**Leigh Anne and Phil Francis**  
**Build a MLK Undercrossing to Better Meet the Purpose and Need**

**Initial Proposed Design for MLK Access Ramps.**

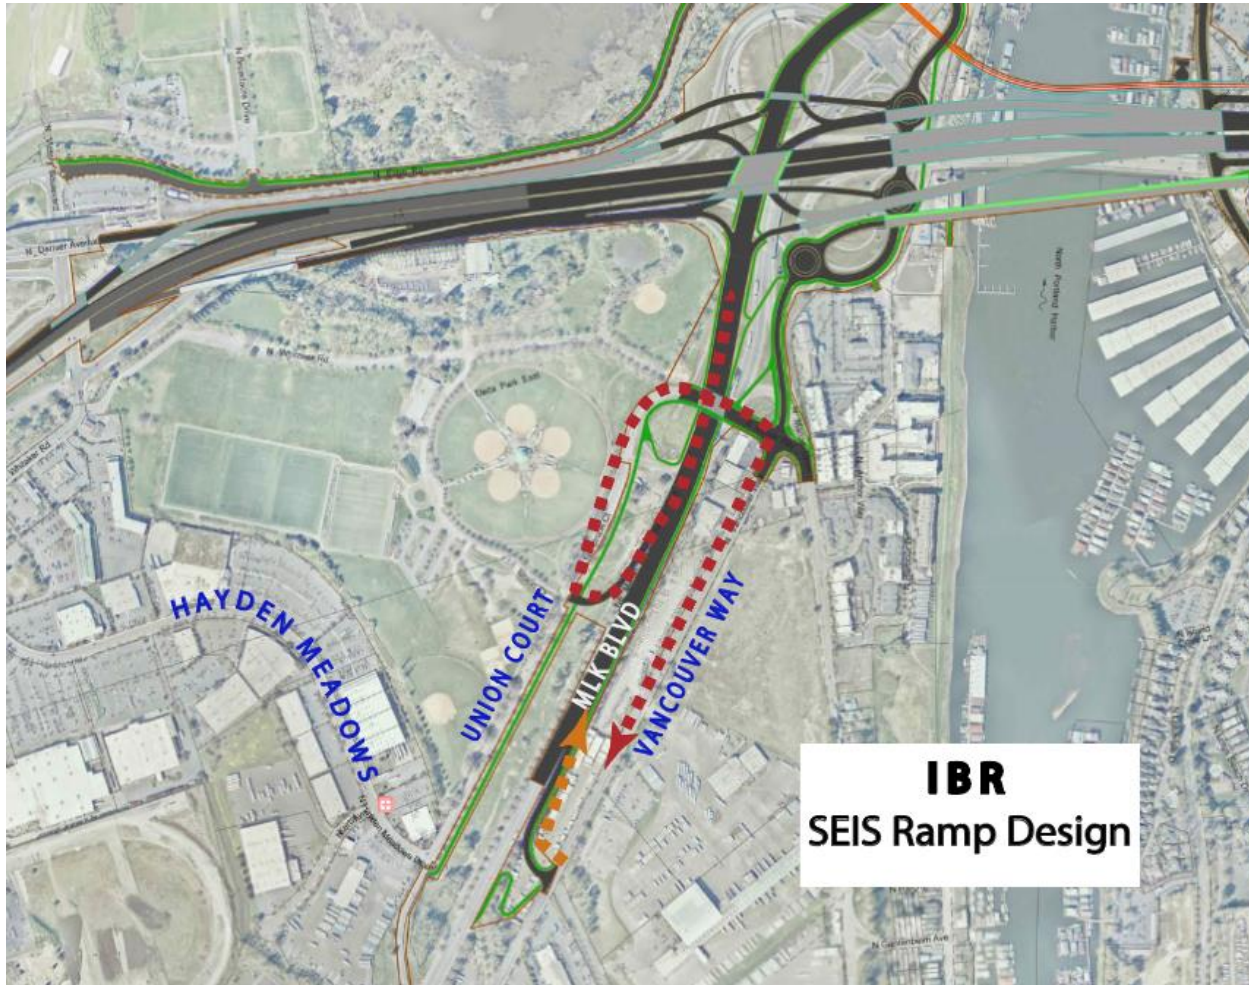
The Interstate Bridge Replacement (IBR) proposes a Martin Luther King (MLK) on-ramp and off-ramp design that meets very minimal requirements:

- 1) These ramps replace the existing ramp connections.
- 2) These ramps merge vehicles onto MLK further away from the Marine Drive single point intersection improving the merge/weave problems with the current intersection.

But this minimal ramp design does not excel with other important goals for Portland including efficient regional freight movement, recreational park safety and understandable way finding.

**Problems with the proposed MLK ramp design**

- 1) The proposed ramp design creates out of direction travel.
- 2) The proposed design is confusing to navigate. A traveler will take the off-ramp to leave the Marine Drive / MLK interchange, but not clearly see how to get back onto the Marine Drive / MLK interchange. There is the same way finding confusion in reverse
- 3) The proposed MLK off-ramp conflicts with Delta Park's primary recreational entrance. Since this a major Freight travel ramp, this ramp should not conflict with the major access to a major recreational area.
- 4) The proposed MLK ramp encourages Freight movement to use East Marine Drive for access when the Freight Master plan wants freight travel to use Columbia Blvd to MLK for Freight Access rather than East Marine Drive which is a local neighborhood roadway.

**Proposal - MLK Undercrossing and Complete Intersection**

There is a better design to meet all of IBR requirements while also meeting broader Portland Freight, Neighborhood and Parks planning goals.

This new ramp design proposes an undercrossing under MLK connecting Hayden Meadows Drive to Vancouver Way. This new MLK undercrossing combined with slightly relocated MLK on-ramps and off-ramps has the following advantages:

- 1) The Complete MLK Intersection minimizes out of direction travel.
- 2) The complete MLK intersection removes Freight users from the main Delta Park Entrance.

- 3) This design would be easier to navigate. It is more understandable for Freight and other users just how to get on and off MLK and the access the Marine Drive Interchange.
